Greensmaster® 3200 and 3200-D

Subject: Missing or mis-located Decal may cause wrong cutting unit set up.

ROLLER BRACKET DECAL INSTALLATION INSTRUCTIONS for GREENSMASTER 3200/3200-D Cutting Units

Ref: 14-06 Copyright[©], 1996. The Toro Company

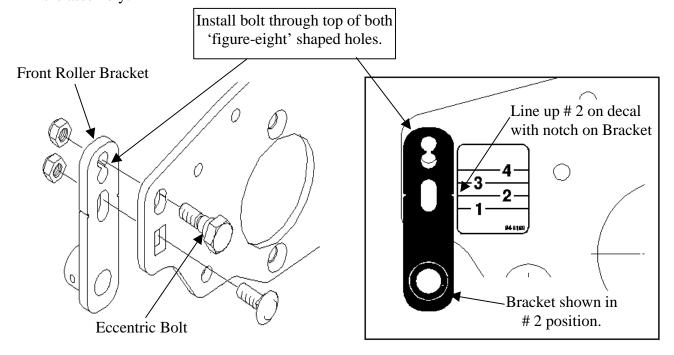
Some cutting units may have been produced without the decal that identifies the front roller position or the decal may have been installed in the wrong location. An incorrectly located decal will result in an improper attitude of the bedknife, which could result in quality-of-cut issues. Replacement decals are available through your local Toro distributor. Instructions for checking the proper decal location are described below.

- 1. Assemble the Front Roller Brackets in the appropriate "Figure-Eight" hole locations as shown.
- 2. The notch on the brackets should align with position 2 on the decal.
- 3. Remove and install a replacement Bracket Positioning Decal (94-8169) as necessary to complete the assembly.
